DEVELOPMENT REVIEW BOARD REPORT

CASE NUMBER/ PROJECT NAME	24-DR-2005 McDowell Mountain Business Center III		
LOCATION	16419 N. 92st Street		
REQUEST	Request approval of site plan and elevations for office/warehouse industrial buildings.		
OWNER	Pavo Holdings LLC 480-443-3992	ENGINEER	Fleet Fisher Engineering Inc. 602-264-3335
ARCHITECT/ DESIGNER	James Elson Architect 480-515-9332	APPLICANT/ COORDINATOR	James Elson James Elson Architect 480-515-9332
BACKGROUND	<p>Zoning. The site is zoned Industrial Park (I-1 PCD) District. The I-1 District provides for manufacturing, processing and research as well as airport uses, warehouses and offices uses. The McDowell Mountain Business Park Planned Community Development District (PCD) provides the overall development standards for the overall business park area and is intended to preserve views of the McDowell Mountains.</p> <p>Context. The site is located in the McDowell Mountain Business Park north of the Westworld event facility and east of the Pima 101 Freeway. The site is surrounded by office/warehouse facilities to the north, east, and west, and the Old Verde Canal berm runs through the property.</p> <p>Adjacent Uses:</p> <ul style="lis

SITE PLAN

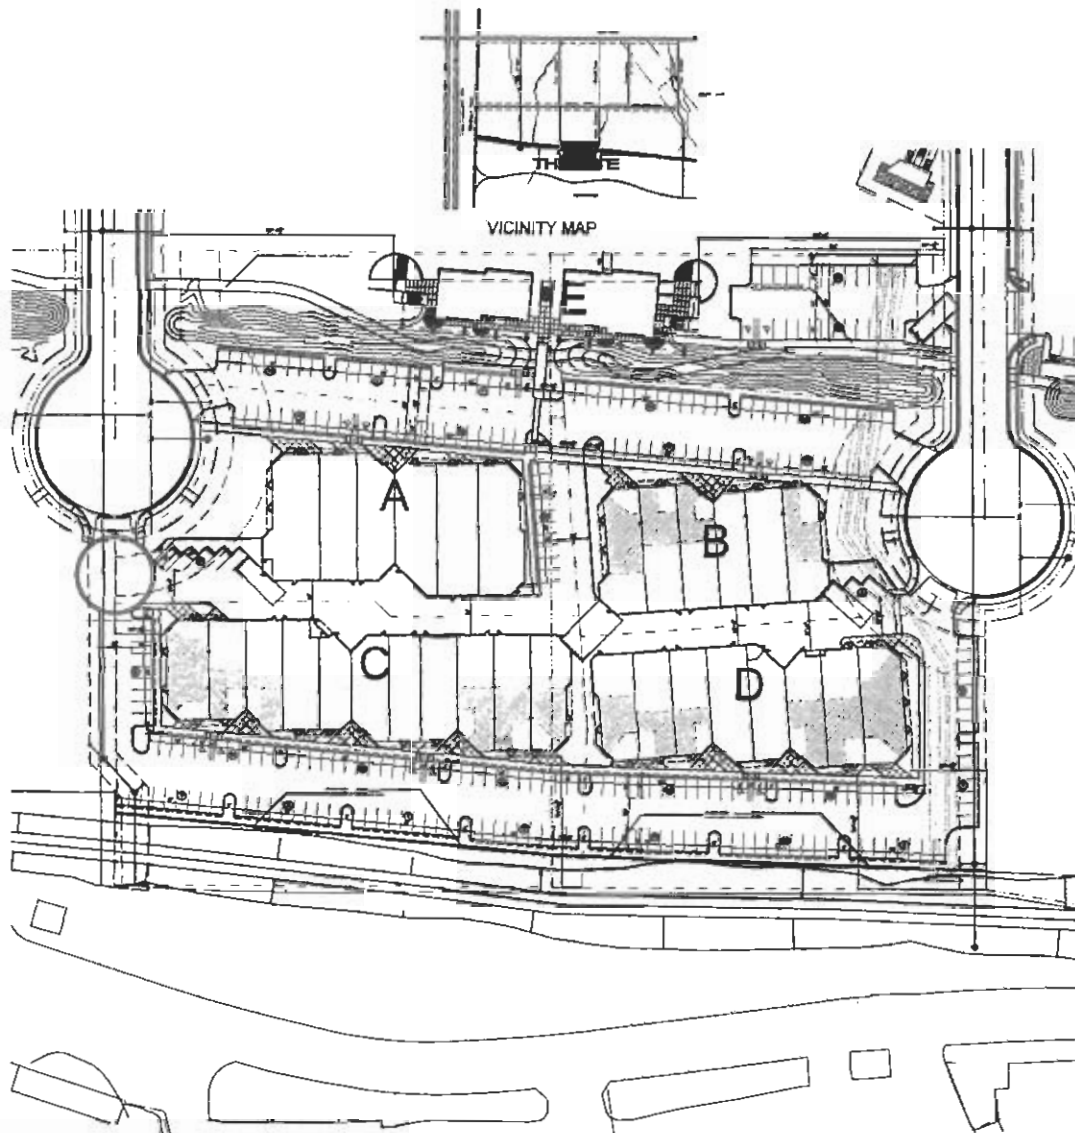
33. The developer shall provide a minimum parking-aisle width of 24 feet.
34. Provide bike parking per COS standard – 14 racks = 28 spaces. Show on site plan.
35. The developer shall provide internal circulation that accommodates emergency and service vehicles with an outside turning radius of 45 feet and inside turning radius of 25 feet.

- 40. The developer shall construct at least 6 refuse enclosures.
- 41. The double refuse enclosure shown in the middle of the site does not provide 40 feet of clear space measured from the face of the enclosure. This area shall be redesigned to provide the 40 feet of clear space.
- 42. Refuse enclosures shall be constructed to City of Scottsdale's standards. Details for construction of trash enclosures can be found in the City of Scottsdale Supplements to MAG Standards, standard detail #2146-1,2(2 is grease containment) for single enclosures and #2147-1,2(2 is grease containment) for double enclosures.
- 43. Enclosures must:

DEAD-END PARKING AISLE DETAIL

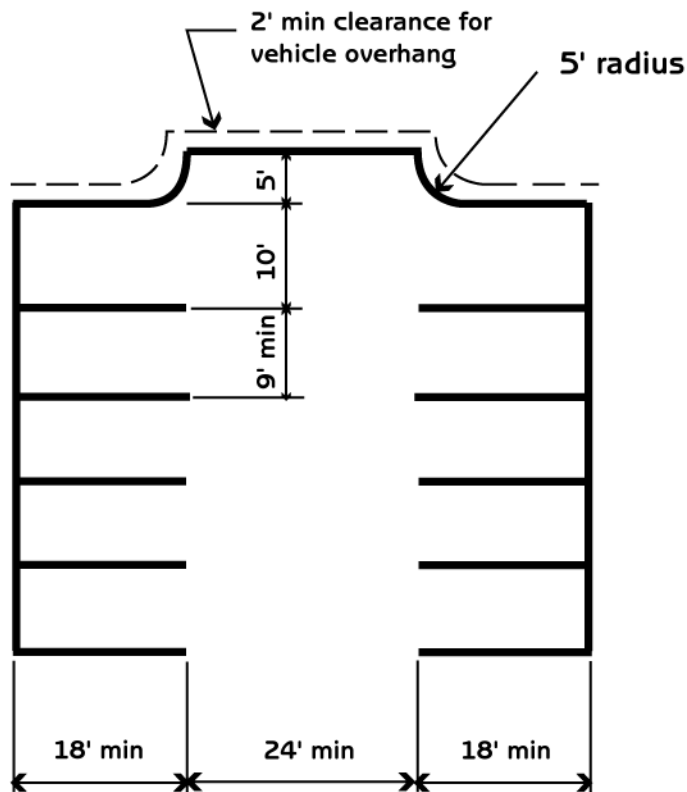
36. The developer shall design the dead-end parking aisle in general conformance with the included detail:

1. Maximum dead-end parking aisle length is 150 feet.
2. If the length exceeds 150 feet, a turn-around shall be provided for emergency vehicles.
3. No refuse enclosures are permitted on a dead-end aisle.
